Date Issued :	January 30, 2023	PCN Number :	513103
Reason for Change :	Change to Product		
Description of Change :	Correction in Product drawings to match sales drawings: no red cap, label distance corrected to REF 100mm, ends of wires should be stripped REF 10mm.		
Reason for Short Notice :	Corrective Actions		
Assessment of Change :	First Article Inspection		
Planned Implementation Date :	February 28, 2023		
Sample Availability Date:	February 15, 2023		
Internal Molex Qualification Date :	February 15, 2023		
Last date to request Samples by Customer :	February 01, 2023		
Traceability Code Markings / Date :	No special marking on the product or packaging

Correction to Product drawings to match Sales drawings for standard receptacle products with engineering numbers: 1Rx000A39xxxx, 1Rx000A20xxxx and 1Rx004A20xxxx

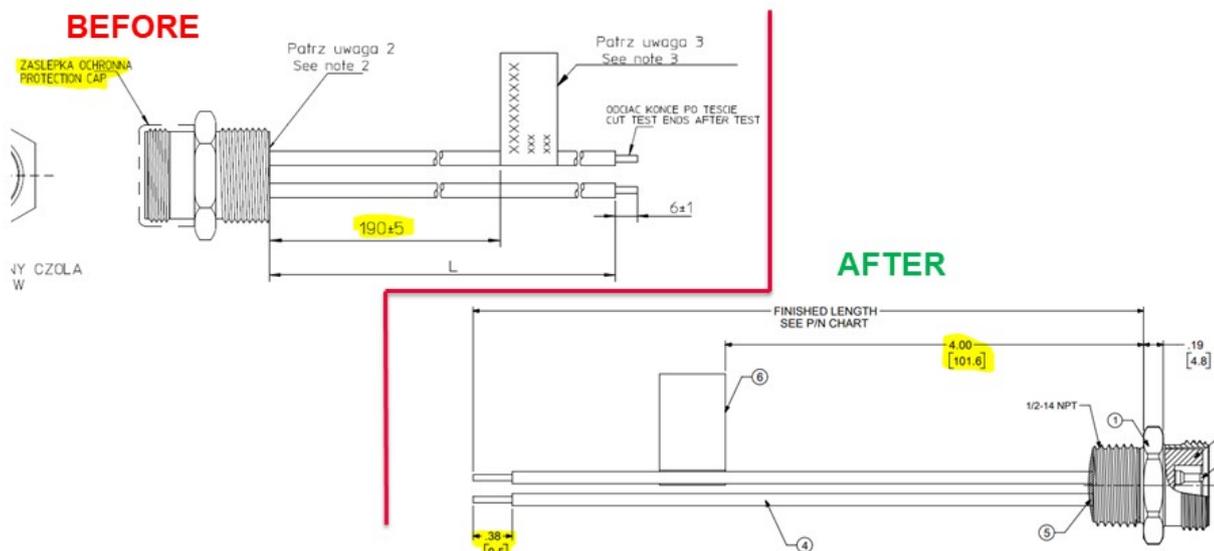
- No red cap needed for standard receptacle products. Label distance corrected to REF 100mm. Ends of wires should be stripped REF 10mm.
